Application for Licence Amendment

Licence Number	L8337/2009/2
Licence Holder	Genesis Minerals (Leonora) Pty Ltd
ACN	667 073 681
Application Number	APP-0030600
Premises	Gwalia Mine LEONORA WA 6438 Legal description - Mining Tenements: G37/25, G37/26, G37/27, M37/17, M37/25, M37/55, M37/137, M37/170, M37/200, M37/247, M37/251, M37/333, M37/391, M37/689, M37/903, M37/1026, M37/1027, M37/1150, L37/33, L37/34, L37/35, L37/36, L37/56, L37/58 and L37/66. LEONORA WA 6438 as depicted in Schedule 1. As defined by the Premises map attached to the revised Licence
Date of Report	25/03/2026
Decision	Revised licence granted

Figure 2: Used tyre storage locations and tyre landfill.

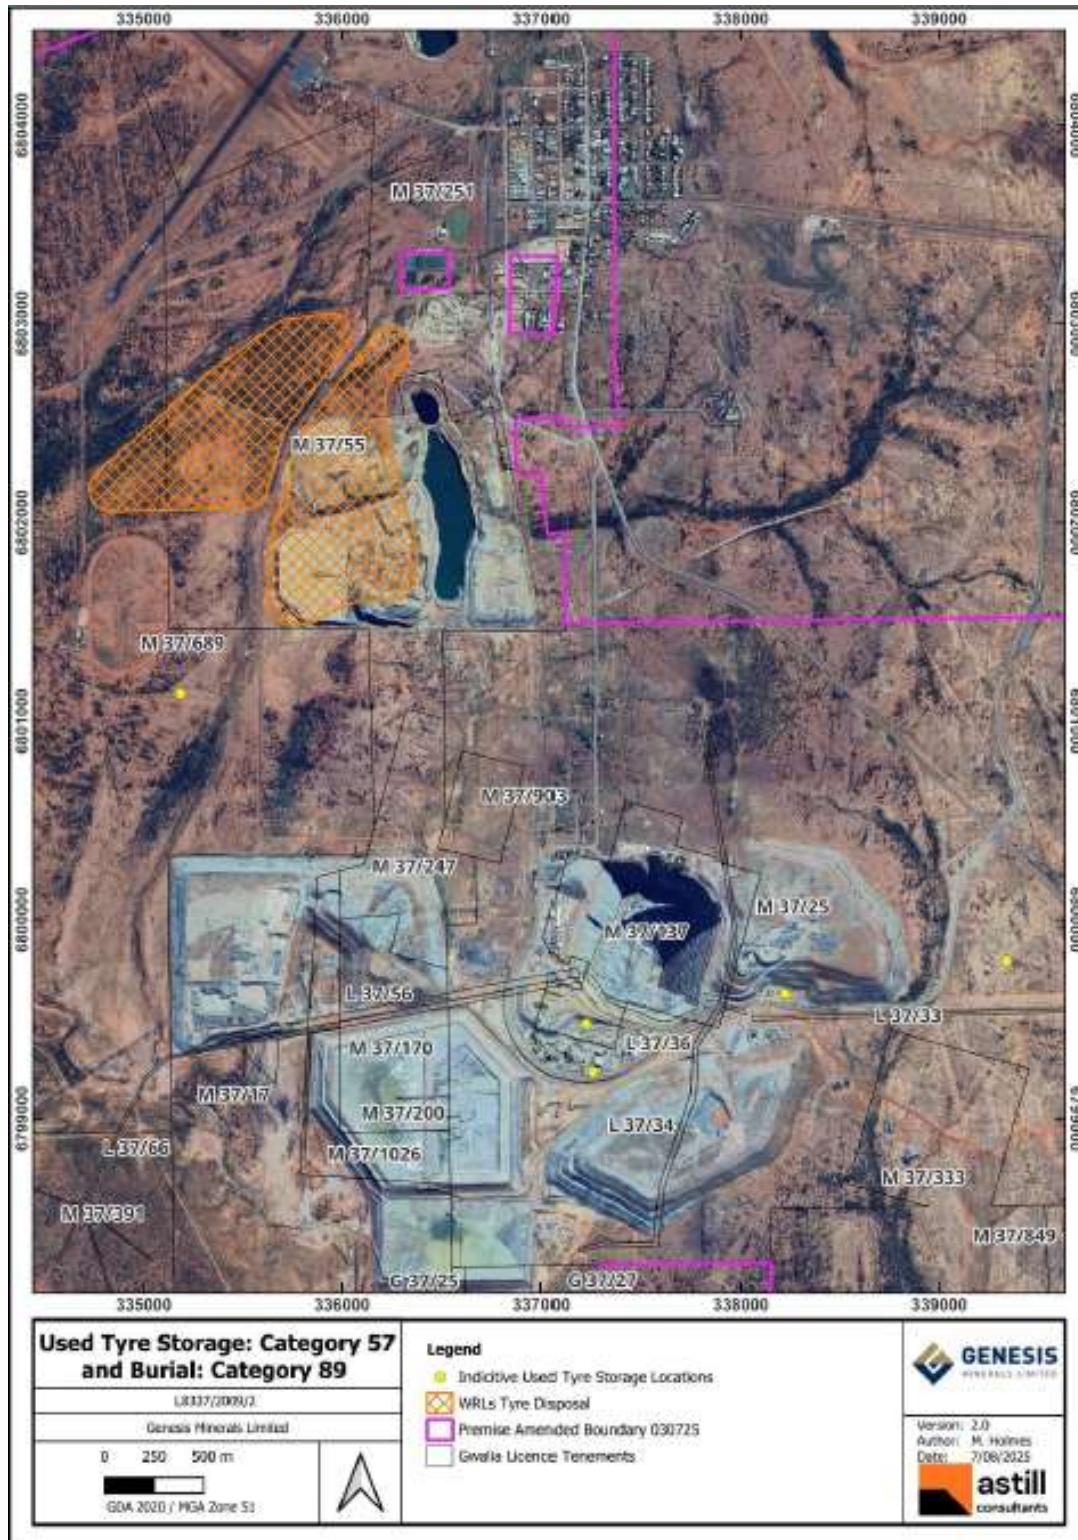
No storage or fire management controls have been proposed by the licence holder.

Within mining proposal 500743 (Talis 2025), tyres are not to be placed within 10 m of WRL edges. However, this licence amendment application proposed a minimum distance of 5 m. To not conflict with mining proposal 500743 (Talis 2025) the departments risk assessment will use the 10 m minimum distance of tyre disposal to the WRL edges instead of the proposed 5 m separation distance.

Figure 4: Historical SWL measurements (Genesis 2025)

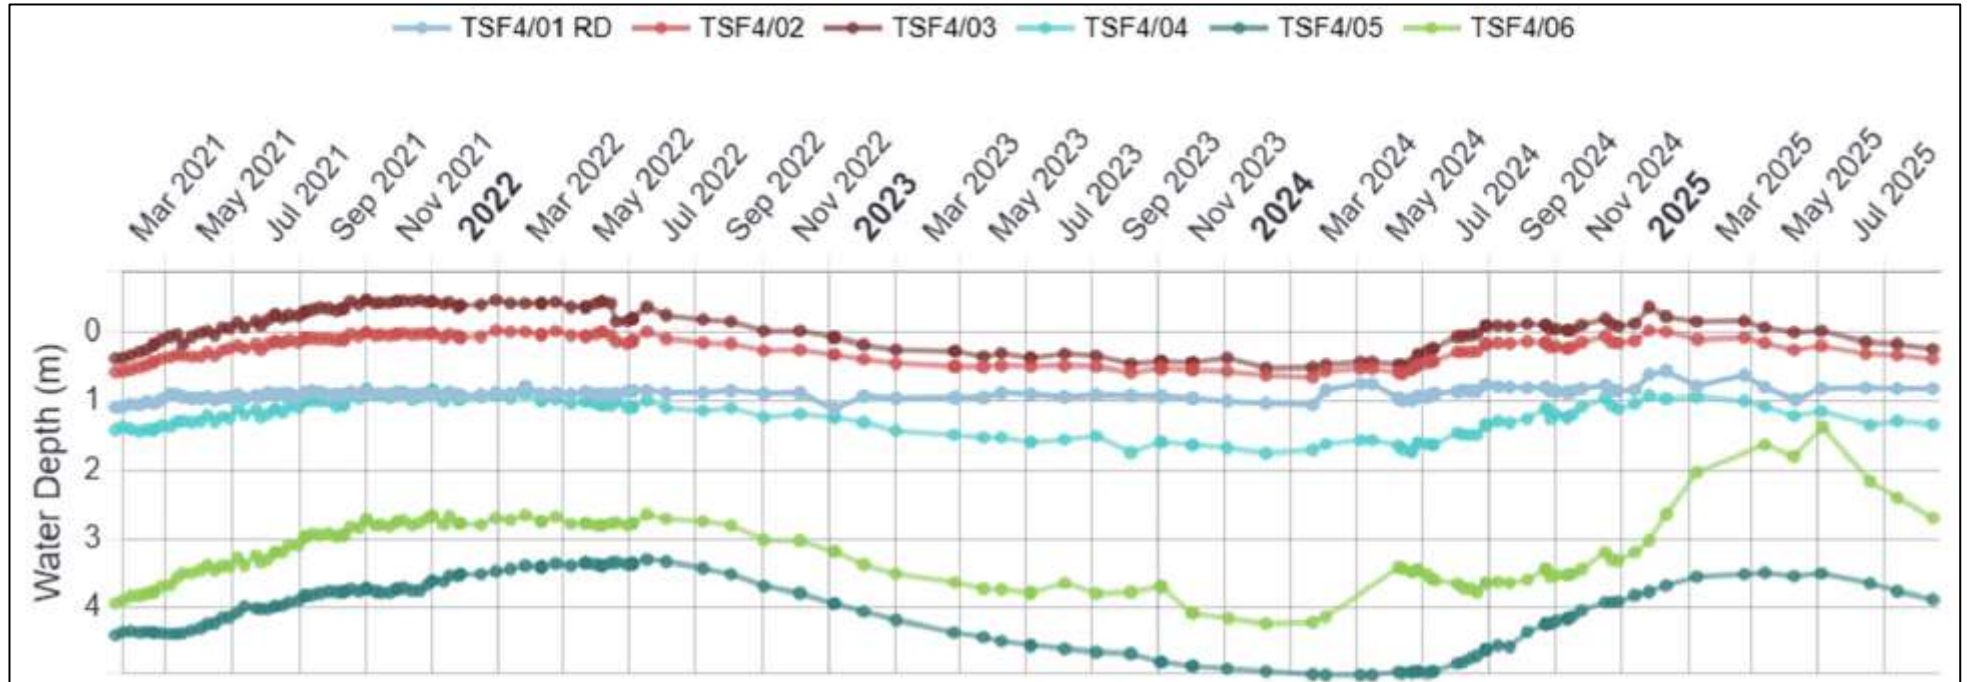
Evidence of seepage and mounding has been recorded during the operational life of TSF4 (Section 9.3.2). Groundwater mounding has occurred historically (Figure 4), particularly within deeper groundwater areas on the eastern side of the facility (bores TSF4/05 and TSF4/06). For this reason, the department has assigned a **Possible** likelihood rating for this risk event.

Seepage and mounding has been recorded throughout the operational life of TSF4, and the shallow groundwater SWL (Figure 4) creates a potential pathway for seepage-affected groundwater to enter the drainage line and be transported towards Lake Raeside during stormwater runoff events. Although groundwater quality data from the TSF4 monitoring bores do not currently indicate significant concentrations of seepage identified within the aquifer (section 8.3.4), there remains a potential for increased seepage concentrations in the future if operational height of the supernatant pond increases and seepage recovery bores do not operate effectively. The department has assessed the likelihood of this risk event as **Possible**.

Figure 6: Cobalt concentrations within TSF4 monitoring bores (Sourced from Genesis 2025).

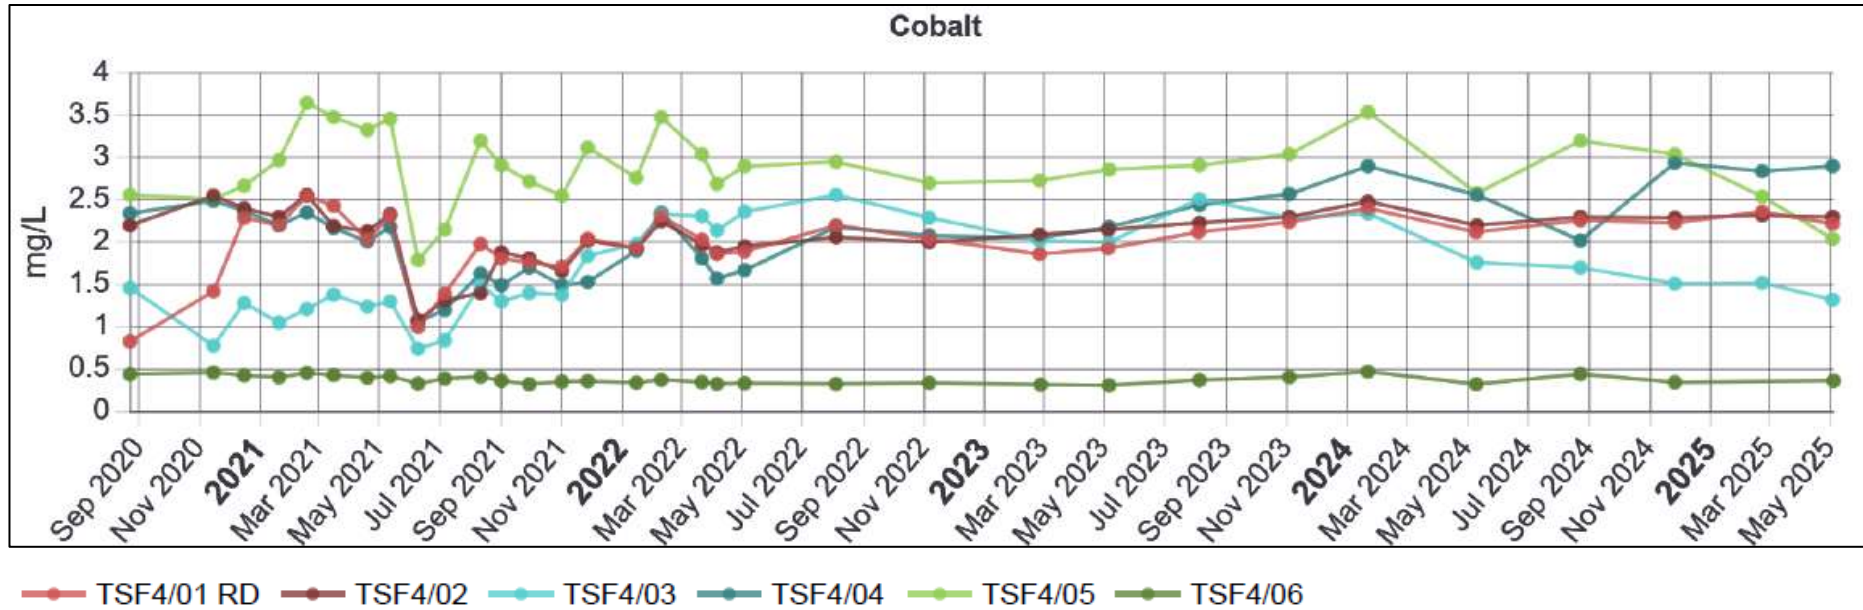
The department considers these concentrations to be overall low and not likely to result in consequential impacts to potential receptors, with the exception of cobalt. Historical cobalt concentrations (Figure 6) suggest that TSF4 has either not contributed, or has only minimally contributed to cobalt levels to the groundwater.
